# **Conceptual Review Agenda**

# 1809 N College Ave Lodging Establishment

September 01, 2016

Re: 1809 N College Ave - Lodging Establishment

Architectural Site Plan I" = 20' - 0" NORTH

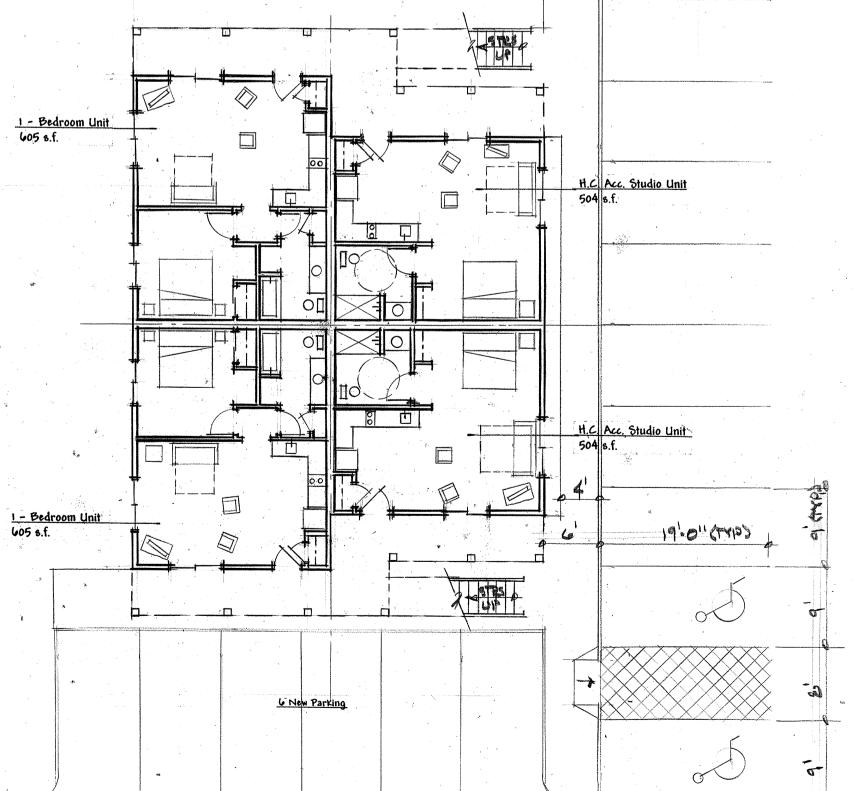
- **1.** The trash enclosure is much too small. You must provide walk-in access as well as a recycling receptacle.
- **2.** A 5 foot landscaped setback is required along the south property line, you are showing 3 foot.

- **1.** The site will need to be platted.
- **2.** The zoning indicated on the site plan is incorrect. The site is in the Service Commercial (CS) District, not the North College Community Commercial (CCN) District.

- **5.** Is there any bicycle parking on the site? The requirements for lodging establishments are 1 bicycle parking space per 4 units, and 60% of the total number of spaces must be enclosed, secured bicycle parking (i.e. lockers or similar). In your submittal please indicate the number, location, and type of bicycle parking on the site plan.

- **6.** How many total parking spaces are on the site? The parking counts shown on the site plan and listed in the "general information" section do not match. For a lodging establishment, the maximum number of parking spaces is 1 per unit (including required handicap spaces). In your submittal, please clarify the parking totals and clearly label all parking spaces.

- **7.** How does vehicular traffic move through the site? The required width for a one-way drive aisle is 20 feet with 90 degree parking, 15 feet with 45 degree angled parking. The site plan appears to meet that standard, but several drive aisles seem too narrow for two-way traffic.

- **8.** A connecting walkway will need to be provided from College Avenue to the main entrance of the lodging establishment as described in Section 3.5.3(C). In addition, walkways must be a minimum of 6 feet in width between building entries and sidewalks. The site plan appears to

- show walkways of 4 feet in width along the eastern side of the proposed building.
- **9.** If there are standards in the Land Use Code that cannot be met, a written request for a modification of standard must be submitted as outlined in Section 2.8.2. The standards governing the approval of a modification are described in Section 2.8.2(H).
